BCA Assessment Report

45-49 Warriewood Road Warriewood

Project: 45-49 Warriewood Road Warriewood
Reference No: 115064-BCA-r1
Date: 17 December 2021
Client: Sanjeev Kumar Loura
Client Contact: Sonya Constantinou
Email: Sonya.constantinou@cpsplanning.com.au
BCA Logic Contact: Alex Newberry
Direct: 0466 811 720
Email: anewberry@bcalogic.com.au

Revision	Date	Description	
115064-BCA-r1	17.12.2021	BCA Assessment Report – DA submission	
		Prepared by	Verified by
		Alex Newberry	Benjamin Long
		Senior Building Regulations Consultant	Registered Certifier Grade A1, No. BDC 3380 Senior Building Regulations Consultant

Figure 2: Block D – Fire Walls 120/120/120 to separate the Class 2 SOU entries from the car park (Block C will require similar Fire Wall separation)

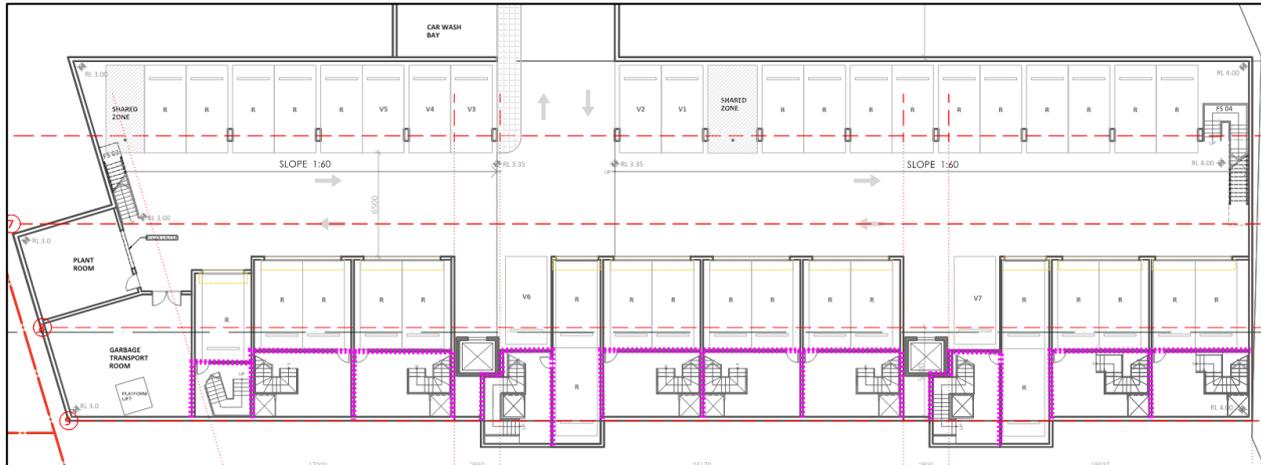
- Basement level and the Ground Floor bin room adjacent Building D are a single fire compartment. The bin lift serves the Ground Floor bin room from Basement level without being a fire isolated shaft.
- Basement Level: The Class 2 SOU entries will be separated by Fire Walls FRL 120/120/120. Refer to Figure 2 below for an example of Block D which is also applicable to Block C. Each SOU will be fire separated from the Basement car park and from the adjoining SOU.

- (c) Ground Floor to Second Floor is a single fire compartment served by non-fire isolated stairs. SOU entries on Basement Level will form part of the fire compartment.

In the Basement Level, the fire walls separating the SOU entries will be protected with self-closing fire doors with FRL -/120/30.

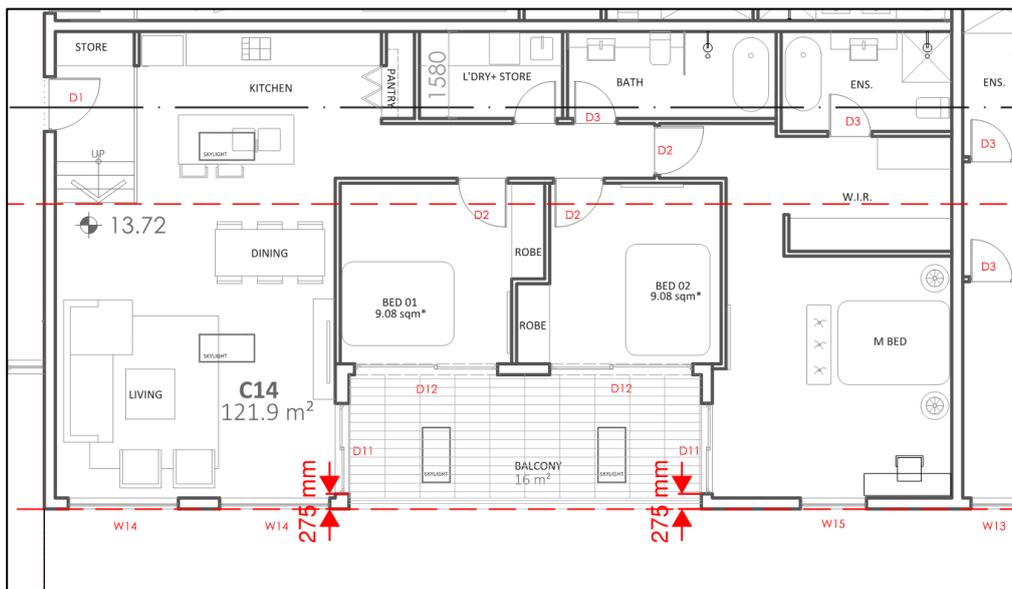
Refer to Part 2.6 of the Report for assessment of the Fire Compartments and Fire Walls required in the basement level to separate the individual SOU entries from the car park. In addition, the non-fire isolated stair FS04 will require Fire Wall 120/120/120 separation to Terrace D10 as it discharges at Ground Level.
